### Item 1: Land Development and Subdivision Code of Practice Update – Stage 3

# QLDC Code of Practice Updates – Stage 3

Progress Update

## QLDC Rainfall Design Storm

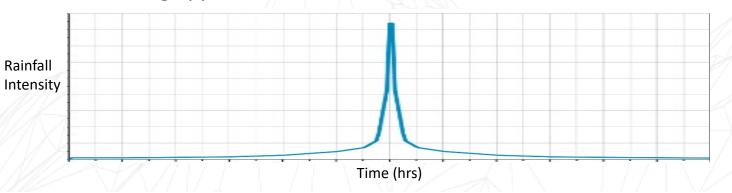
- QLDC refer to requiring a 24-hr nested design storm for modelling but minimal detail on this
- Often a design storm from Auckland is used (TP108) as a default however different climate and rainfall environment
- Can be a lack of consistency in modelling approaches

- Rainfall profiles/design storms have been requested from various consultants
- Example calculations have been requested
- Feedback nested storms aren't necessarily required anymore as computing power increases

- Some work has been done already with BECA for internal design storms for catchment modelling
- Looking at continuing with this, creating a QLDC storm profile and methodology consistent with finalised 2024 COP with example calculations
- Potentially timing and QA may not make this practical to release with this COP, and may be better as advice note
